Official Transcript of Proceedings
NUCLEAR REGULATORY COMMISSION

Title: Advisory Committee on Reactor Safeguards

Date: September 8, 2011

586TH MEETING

Figure 6-4: Large Scale Test Facility

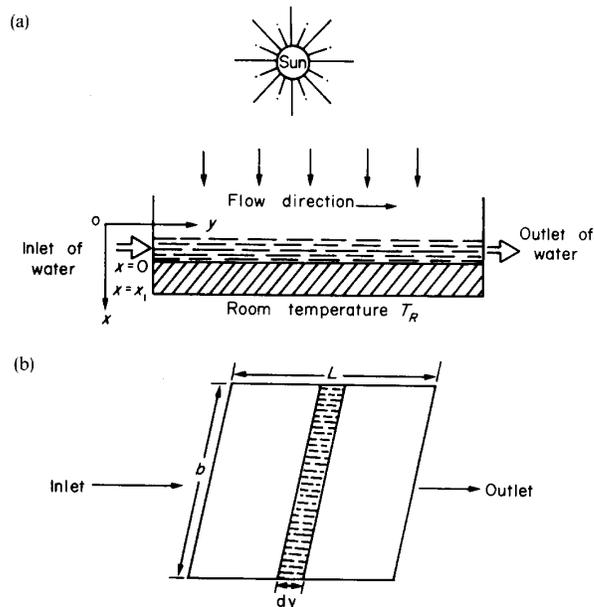
If the above is a photograph of the site on which the test was performed (i.e., if the test was performed outdoors during the day), which I believe it is, then the wetted surface of the Large Scale Test (LST) of the Passive Containment Cooling System (PCS), was in the presence of the sun when the experimental test data was taken. The figure below, which is from an article in an engineering journal (Ref. 3) is applicable to that situation, and the factors depicted in it need to be taken into account when interpreting the test data:

The above figure (Figure 1 of Tiwari 1981) correctly depicts the role of the sun in the **Large Scale Test situation** of the Passive Containment Cooling System (PCS) LST, which, it appears, was performed outdoors, in the presence of sunlight.

Passive Containment Cooling

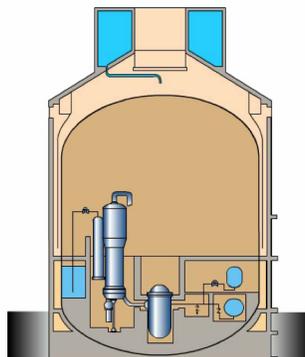
The problem is that it appears that in the test situation (PCS LST) against which the computer code WGOthic was compared, the wetted surface was exposed to solar insolation (i.e., radiative heating from sunlight was present), whereas the situation WGOthic is being used to make predictions about is one in which it is not: inside the shield building, which is where the PCS delivers the water film over the steel containment. The interior is largely shielded from sunlight. The Westinghouse presentation at an NRC meeting on 30 June 2011 presented this figure:

It was also stated that the computer code WGOthic was used in the safety analysis for the AP1000 to predict PCS effectiveness in removing heat from the containment, and thus to predict its effectiveness in reducing containment pressure. Per the docket materials submitted describing the analysis performed in calculating containment pressure for Rev 19 changes, the computer code was validated by comparing the results that WGOthic predicted for the LST test with the results obtained experimentally in the LST test.

Figure 6-3: Small Scale Test Facility

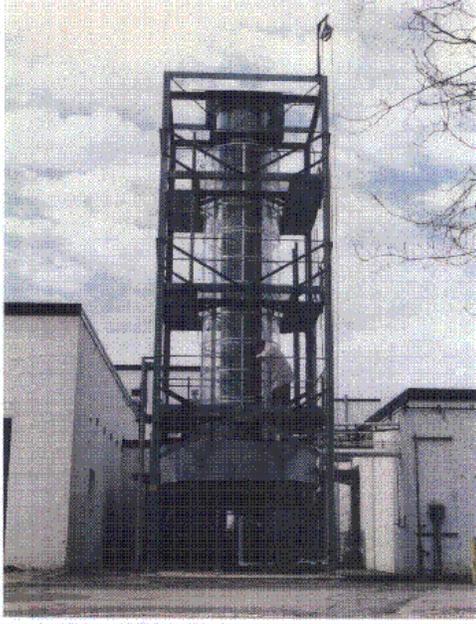
The photograph of the Small Scale Test Facility, also taken from material submitted for rev 19 of the AP1000 DCD, likewise portrays it outdoors, so agreement between the small scale test experiments run on this facility, and the large scale tests cannot be appealed to in order to dismiss the significance of the test being performed outdoors:

3. Question to the NRC ACRS about WGOthic validation for Rev 19 Containment Pressure Calculations
